**RE: Nusenda Credit Union
6401 Uptown Blvd NE
Grading and Drainage Plans
Engineer's Stamp Date: 1/5/26
Hydrology File: H18D012
Case # HYDR-2026-00001**

GRADING and DRAINAGE PLAN

A NEW BRANCH AND DRIVE THROUGH FOR:

1 | grading and drainage plan
C101 | 1"=20'-0"

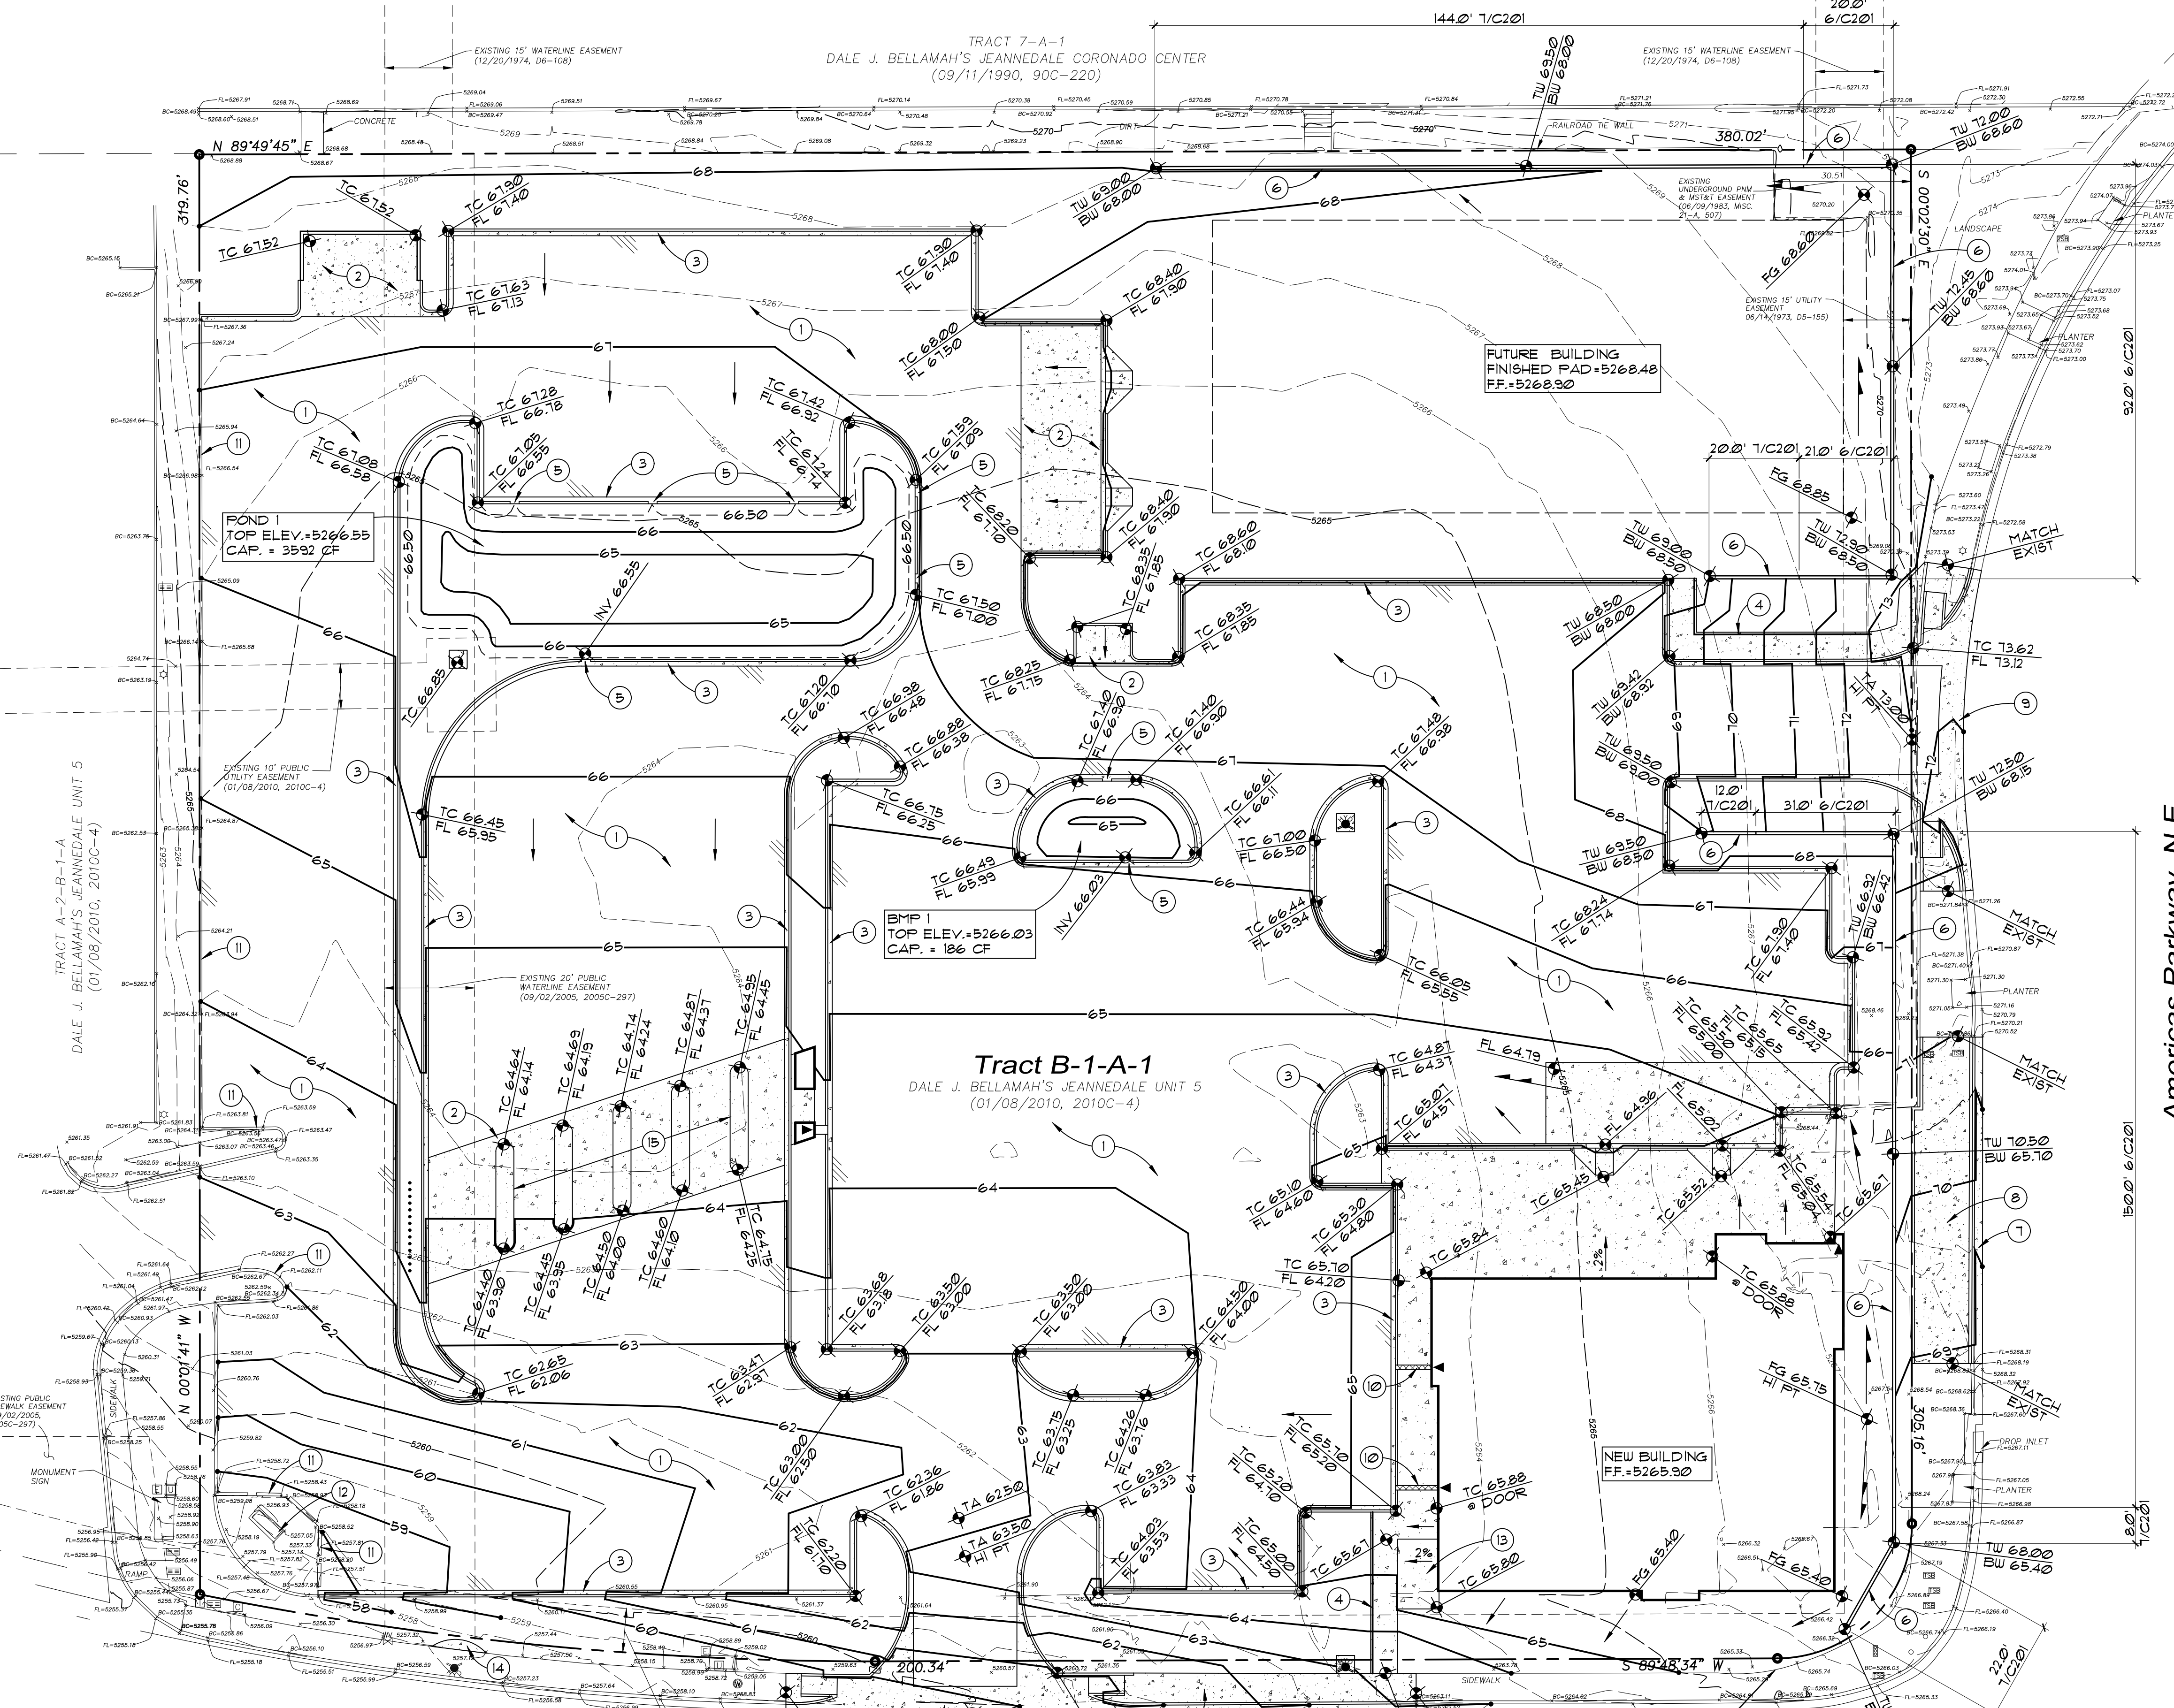
Based upon the information provided in your submittal received 1/8/2026, the Grading plan is **approved** for Building Permit. Please attach a copy of this approved plan in the construction sets for Building Permit processing along with a copy of this letter.

1. Engineer's Certification, per the DPM Part 6-14 (F): *Engineer's Certification Checklist For Non-Subdivision* is required.

2. Please provide the Drainage Covenant with Exhibit A for the stormwater quality ponds per Article 6-15(C) of the DPM prior to Permanent Release of Occupancy. Please submit the original copies along with the \$ 25.00 recording fee check made payable to Bernalillo County to the Hydrology Section of Development Review Services on the Ground floor of Plaza de Sol. Electronic submittal to ABQ-PLAN is also required.
